MEMORANDUM

Subject: **Comments on Montgomery & Associates draft Memorandum, “Results of Computer Modeling Agreement for SVWC and SBWA,” dated August 22, 2025**
Project No.: 018-09

To: Abby Ostovar and Derrik Williams, Montgomery & Associates
CC: Nancy Isakson, Salinas Valley Water Coalition
Eric Robinson, Kronick Moskowitz Tiedemann & Girard
Piret Harmon and Emily Gardner, SVBGSA
Bob Abrams, Aquilogic
From: Dwight L. Smith, PG, CHg, Principal Hydrogeologist
Date: October 18, 2025
Subject: **Technical Review Comments on Montgomery & Associates' Superposition Modeling
Technical Memorandum dated August 22, 2025**

Changes in Groundwater Elevations, Figures 2 through 5 and Figures 9 through 12

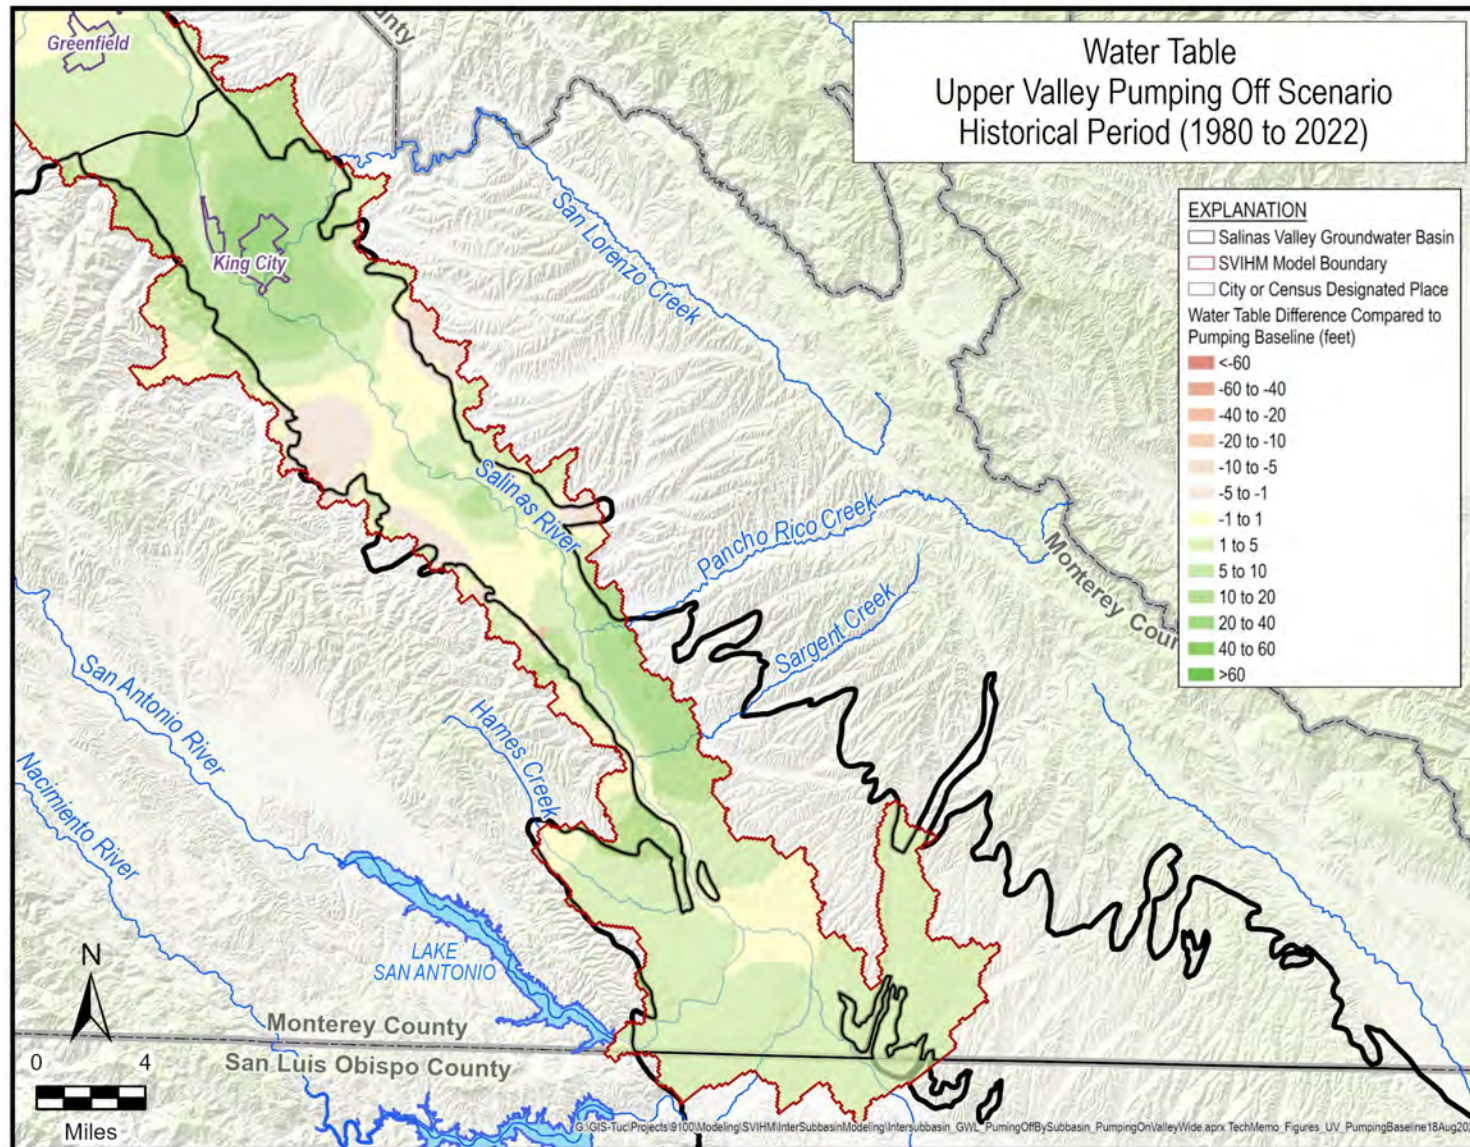
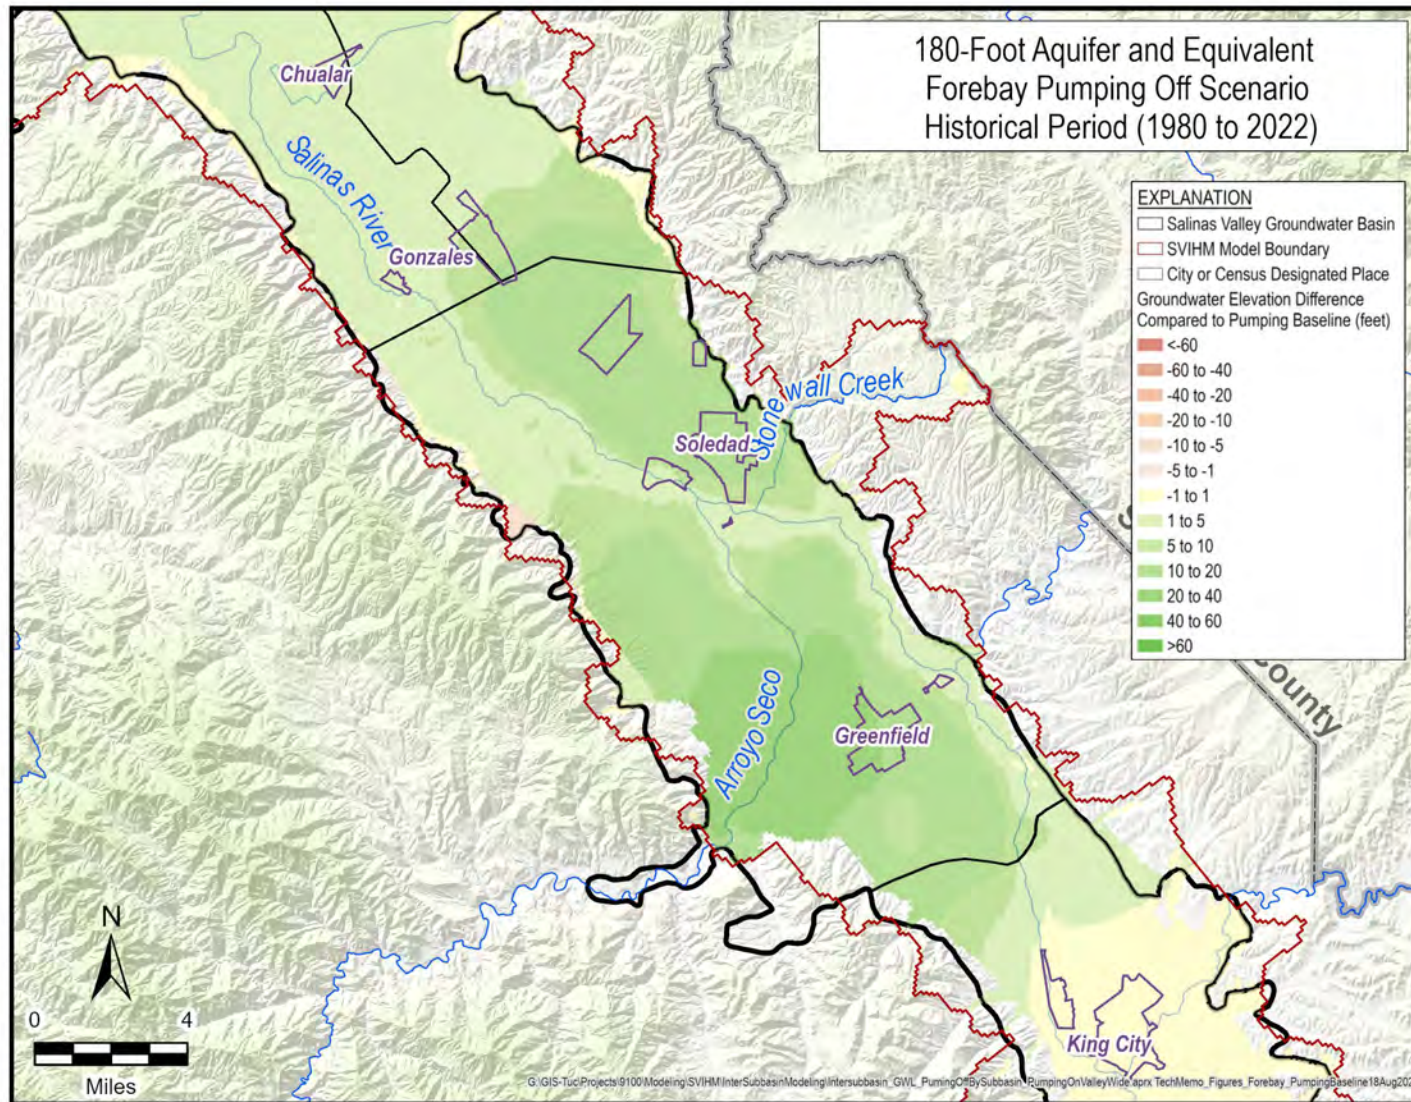
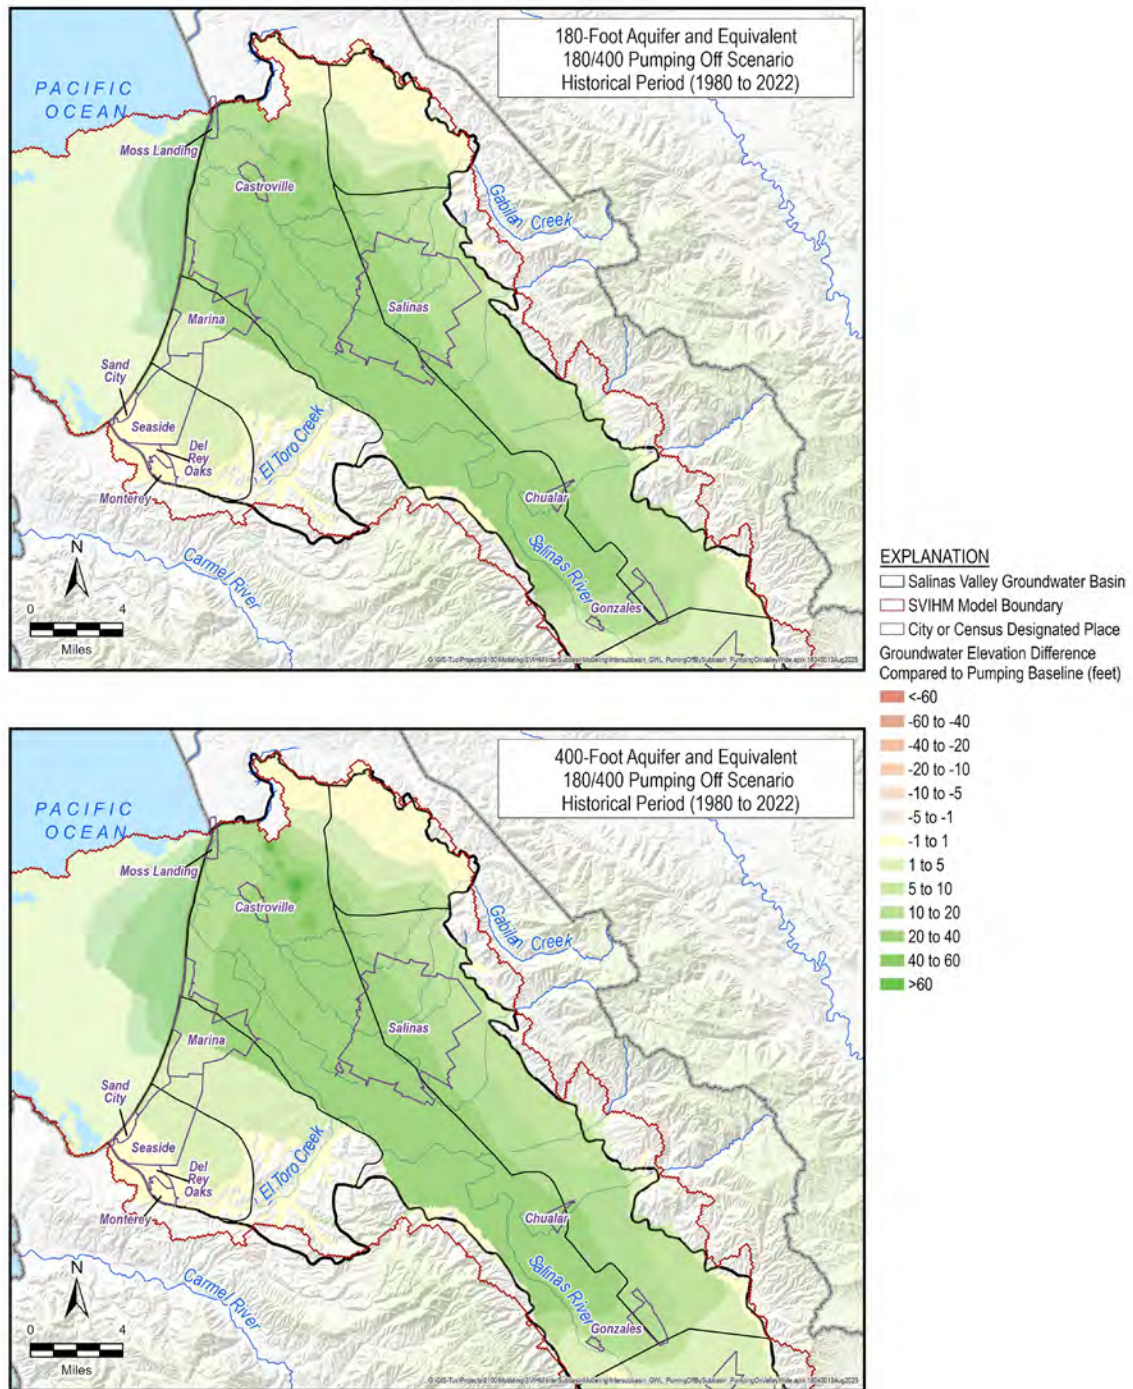
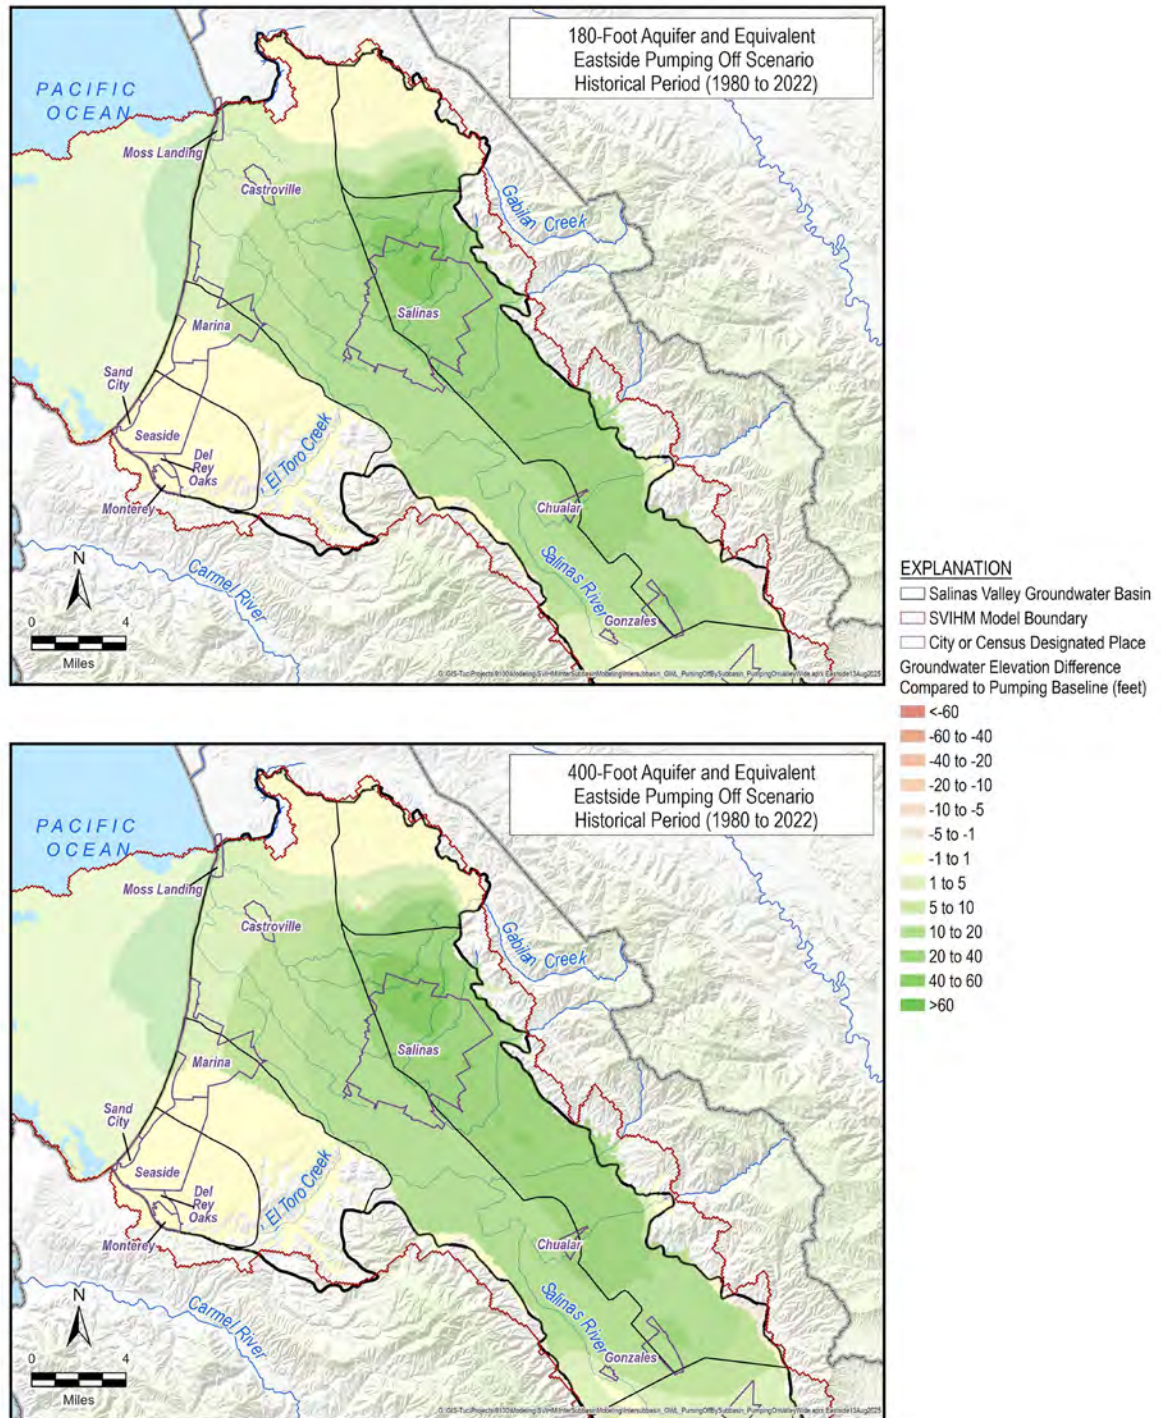
The figures in the draft M&A memorandum are generally informative. However, Figures 2 through 5 and Figures 9 through 12 do not show the results of interest. These figures show the groundwater elevation changes in the subbasin for which pumping was turned on or off. They do not show the impact of pumping in one subbasin on water availability in adjacent and downgradient subbasins. M&A provided draft "replacement figures" at **aquilogic's** request but did not update their draft memorandum.

Further, the color ramps used for Figures 2 through 5 and Figures 9 through 12 make it difficult to understand the modeling results, because the shades of green or red are nearly identical for several of the contour intervals. For example, these figures make clear that pumping in the UV and FB lowers groundwater levels in the 180/400. However, the magnitude of the impacts cannot easily be discerned. We suggest here that labeled contour lines be superimposed on the color shading.

The replacement figures are particularly difficult to decipher, due to the issues noted above with the color ramp, as well as the scale of maps. **Aquilologic** suggests that each figure should be split into three parts. These parts should zoom in on: (1) the 180/400 and ES; (2) the FB; and (3) the UV. The revised replacement figures should be included in a revised draft of the M&A August 25, 2025 draft memorandum.
